ENCLOSURES:
Addl info regarding proposed changes to the Tech Specs & Bases for Nine Mile Point Station

NIAGARA MOHAWK POWER CORPORATION

Re: Docket No. 50-220
License DPR-17

We submit the additional information requested in your letter of March 21, 1972 regarding proposed changes to the Technical Specifications and Bases for the Nine Mile Point Nuclear Station. Since testing of the new relief valve set points requires deinerting and access to the drywell, we plan, subject to your approval, to make these changes and perform the necessary testing during the current station outage.

K_{∞} (HOT) VERSUS PERCENT IN CHANNEL VOIDS
INITIAL FUEL-UNCONTROLLED CURTAINS-ZERO EXPOSURE

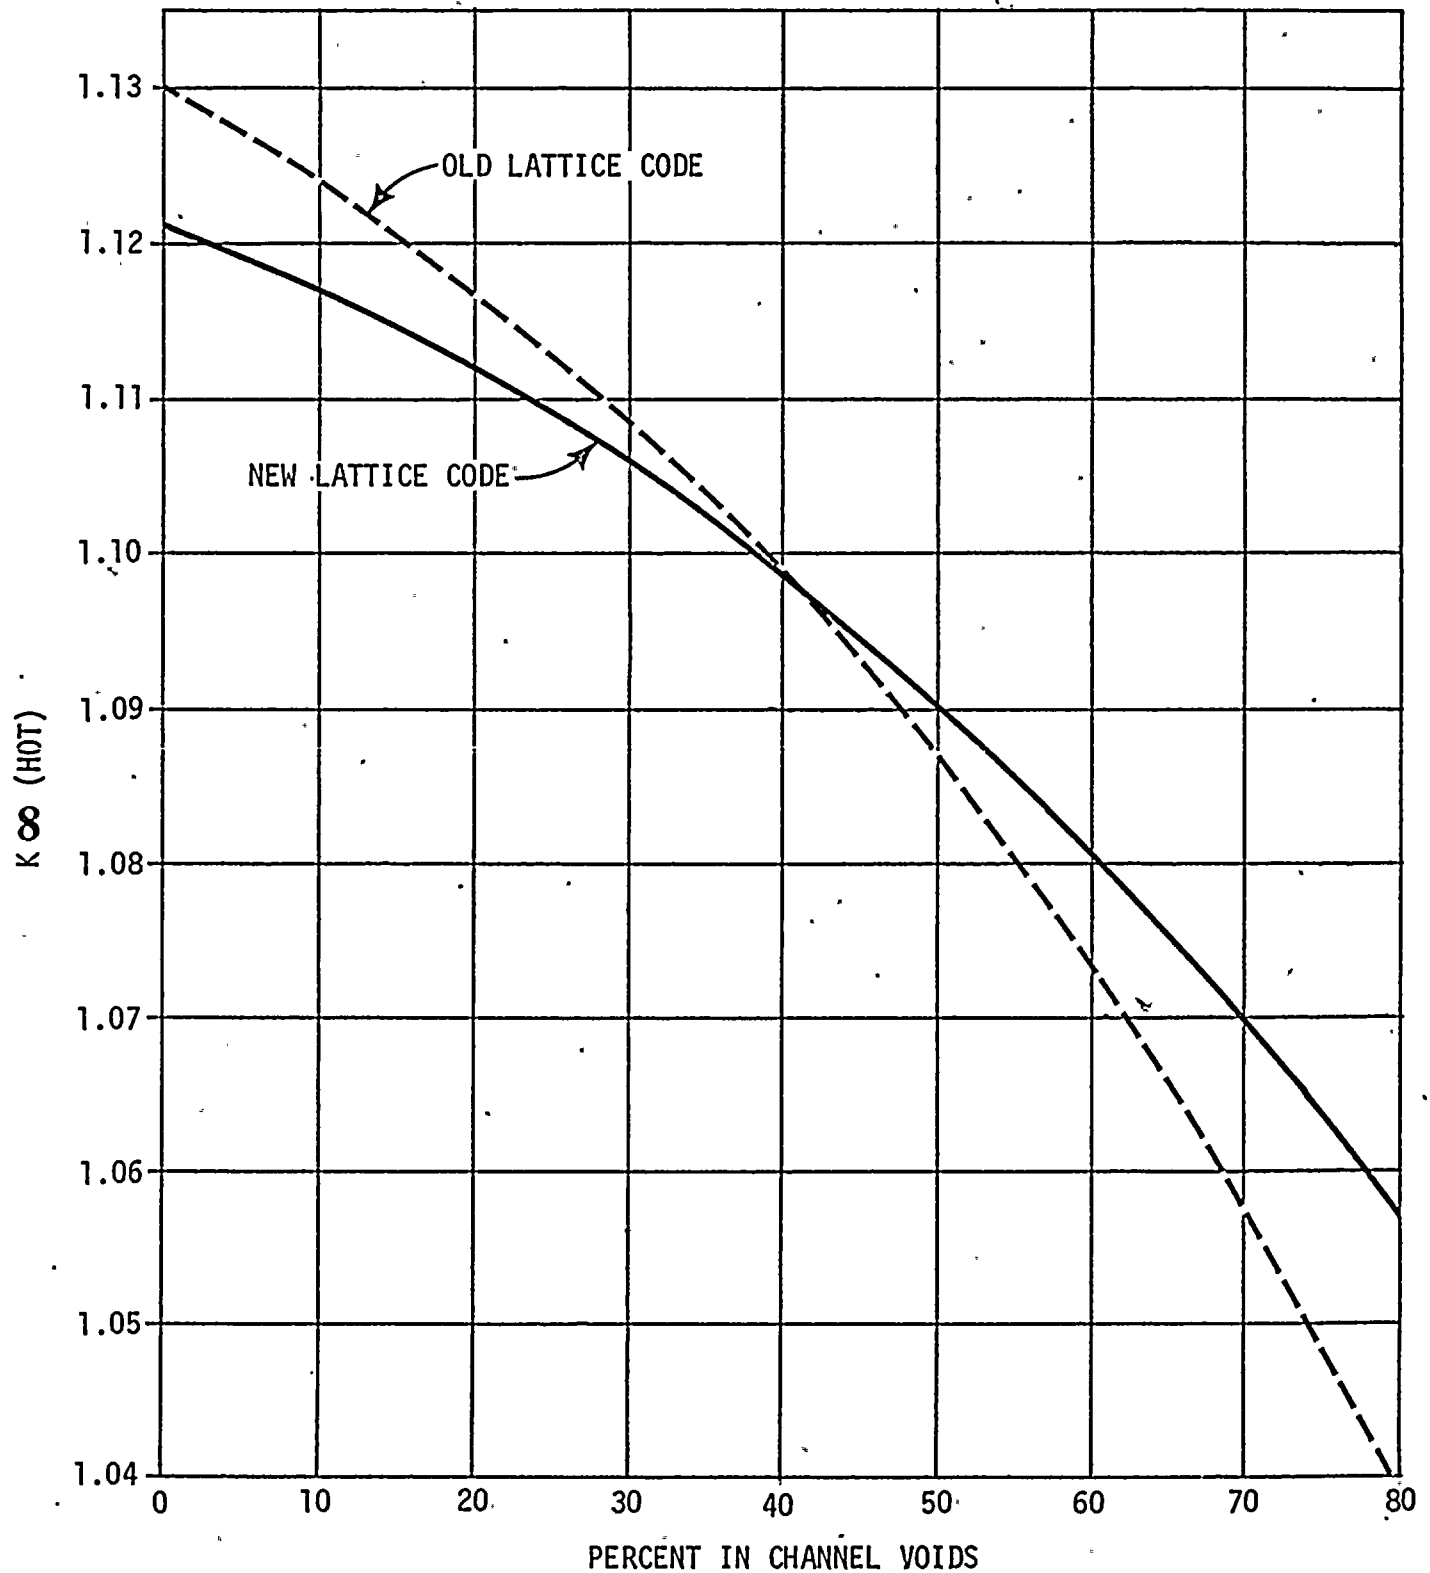
You state that improved analytical techniques available at General Electric Company caused you to adopt the proposed revised scram reactivity curve, but no information regarding these techniques was provided. Describe the analytical techniques used previously, the changes being made to the analytical model, and the basis for considering the change an improvement.

The newer lattice code results in an improved calculation of k_{∞} 's. A significant difference in the k_{∞} predicted by each lattice model can be seen by examination of the curves in Figure 1-1. The new lattice code predicts higher k_{∞} 's at high void and lower k_{∞} 's at lower void conditions relative to the older lattice code. This results in a lower predicted peak power at the bottom of the core which reduces the initial rate of scram reactivity.

FIGURE 2-1
NINE MILE POINT REACTOR
AXIAL EXPOSURE DISTRIBUTION

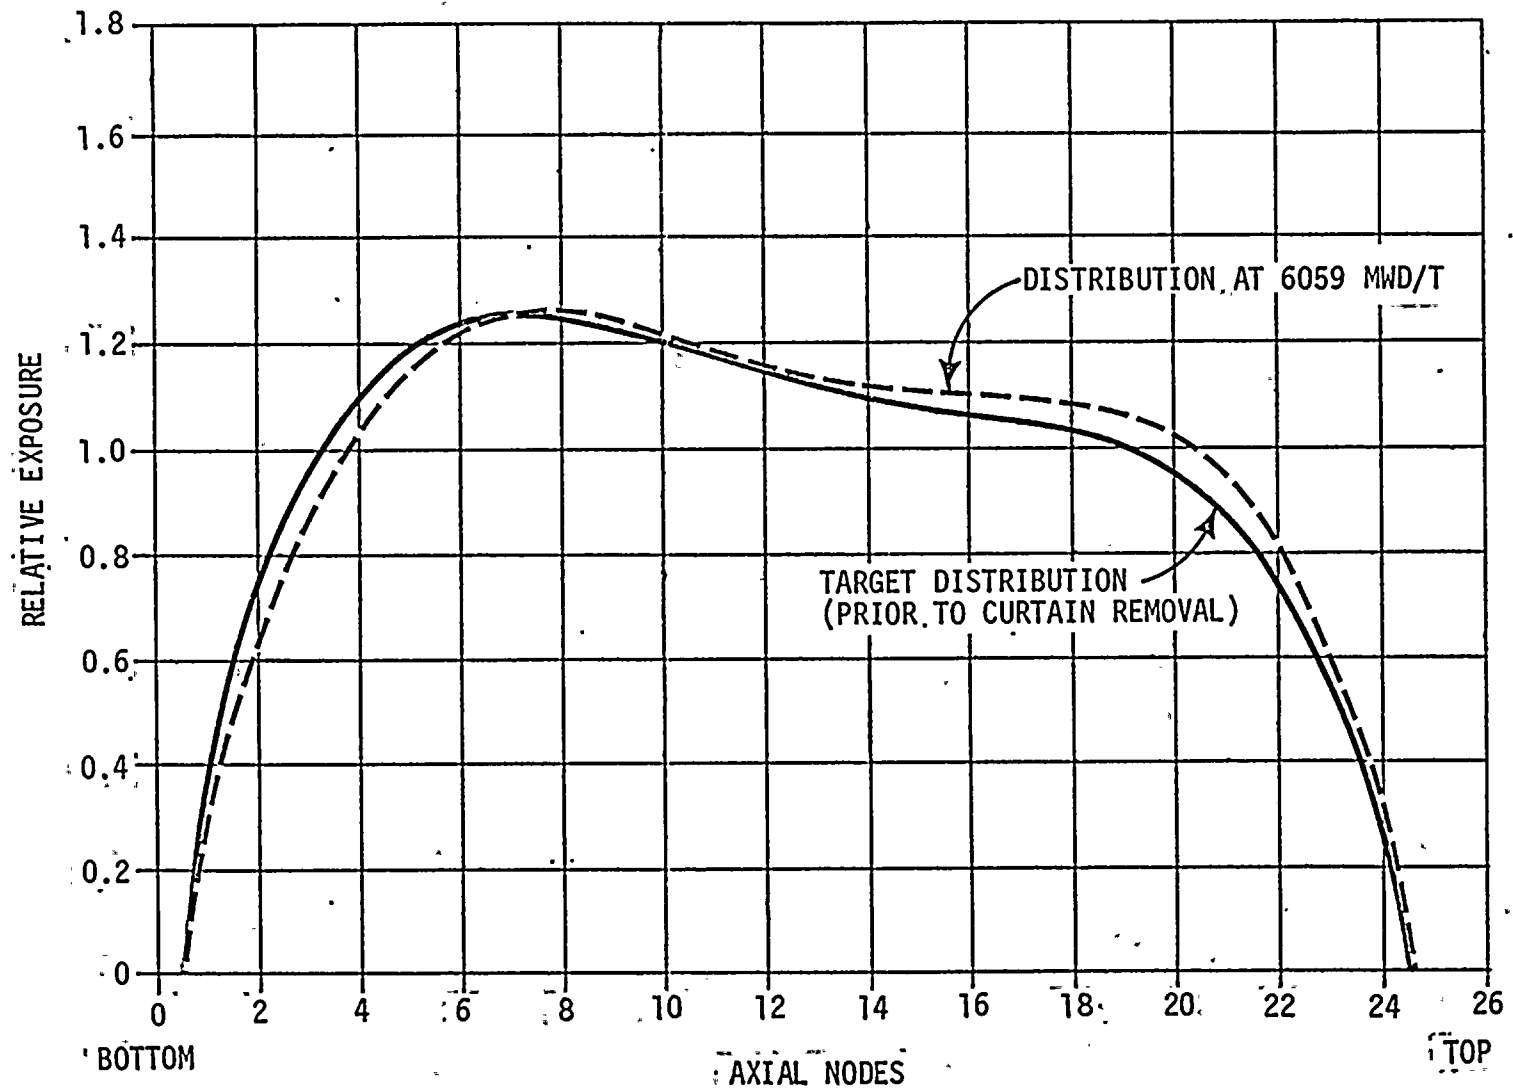
Describe the data and measurements obtained at Nine Mile Point from reactor operations and tests that support use of the new analytical techniques.

The management of control rod patterns at Nine Mile Point has enabled the core to develop and maintain an axial power distribution and, therefore, an exposure distribution, consistent with the objective of minimizing power peaking throughout each operating cycle. Figure 2-1 compares the exposure distribution calculated from Nine Mile Point reactor operation as of January, 1972, with the "target" exposure distribution derived from the Haling principle. The "target" exposure distribution has been computed for an all rods out condition prior to removal of control curtains, it does not represent the equilibrium end-of-cycle condition.

NINE MILE POINT
SCRAM REACTIVITY CURVES

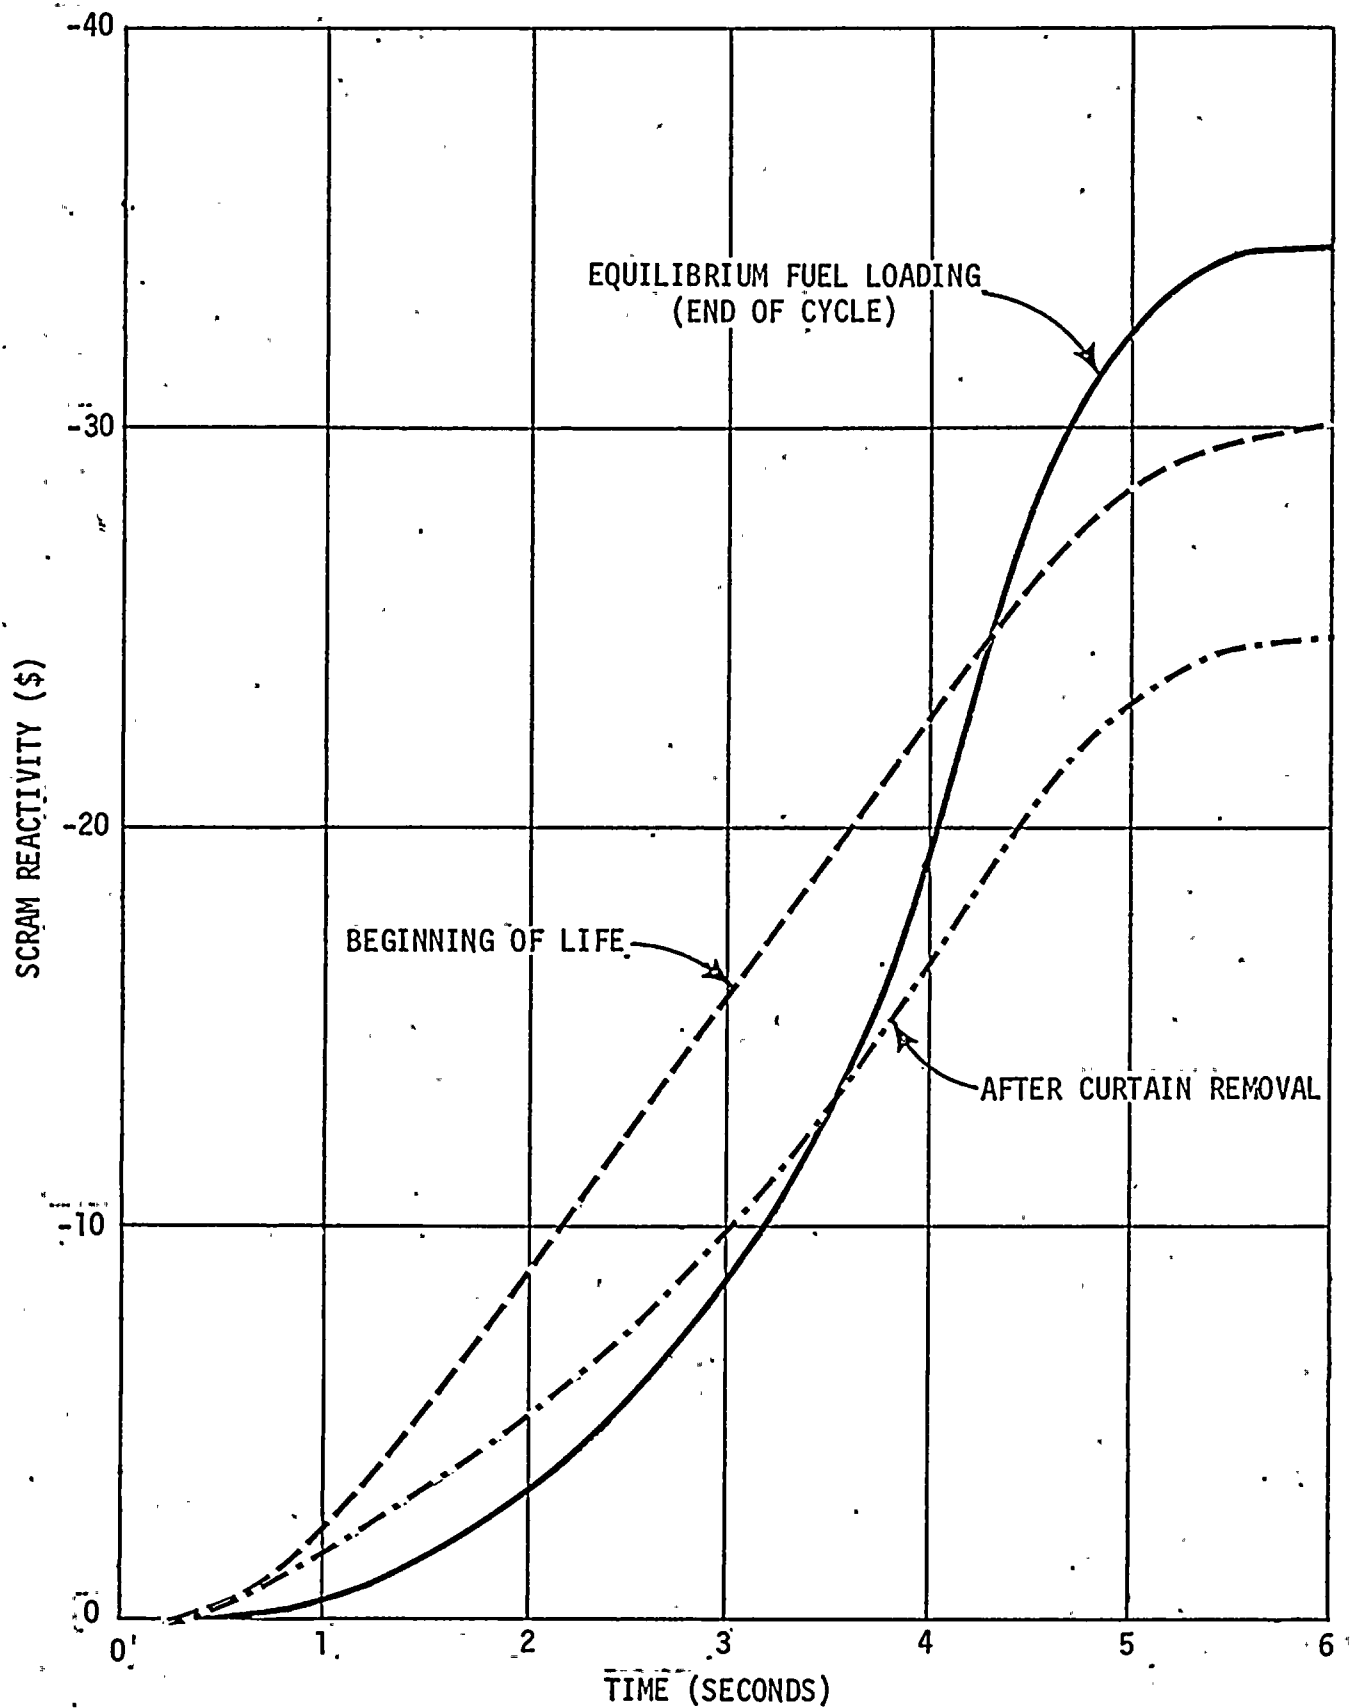
The effect of partial refuelings on the scram reactivity curve has not been presented. Please define the relationship of the present core loading with the scram reactivity curve and describe the effect on the scram reactivity from approaching an equilibrium fuel loading, including the expected operational control rod patterns.

Additional calculations have been made of a conservative scram reactivity curve typical of the period immediately following removal of control curtains. These results are shown in Figure 3-1 along with curves used in previous analyses. All of these scram reactivity curves are conservatively based on a scram time of 5 seconds for 90 percent insertion; a condition which does not exist at this station. Figure 3-1 indicates there will be a gradual reduction in the initial scram reactivity insertion rate as the core approaches an equilibrium condition. Figure 3-2 shows an axial control rod position and the resultant relative axial power distribution which is typical of expected reactor performance following the curtain removal.
